Earth fault which interferes with the temperature gauge

Applies to DC11 and DSC12.

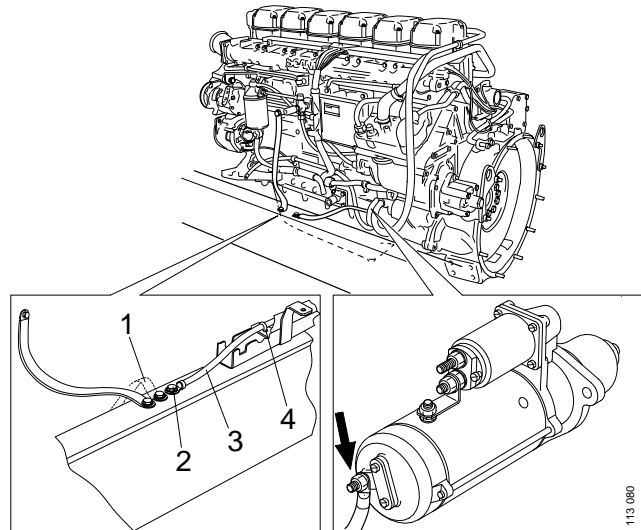
There have been incidences when the coolant temperature gauge has indicated an incorrect temperature. Inadequate earthing between the chassi and the engine is the cause. Currently earthing is achieved between two earth braids which are placed in the engine frame and side-covers.

One of the earth braids 1 378 852 is removed in production and replaced by an earth cable. One of the earth cable ends is fitted to an already existing hole in the frame and the other end is fitted to the starter motor, see illustration.

- 1 *Outgoing earth braid 1 378 852*
- 2 *Screw 813 005*
- 3 *Earth cable 1 378 324*
- 4 *Strap 815 363*

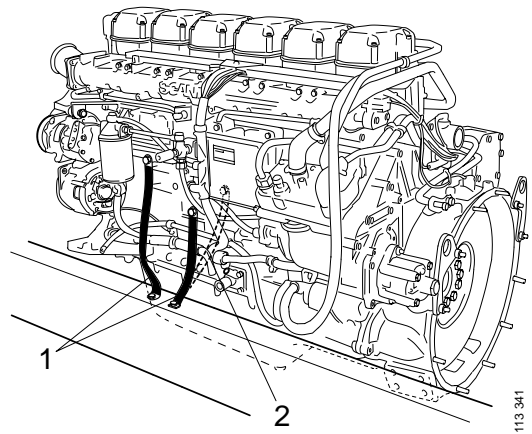
Move the rear side cover earth braid to a suitable casting protrusion on the cylinder block. Scrape off the colour on the cylinder block before fitting the earth braid to the new earth point.

- 1 The old production solution.
- 2 After the service solution.
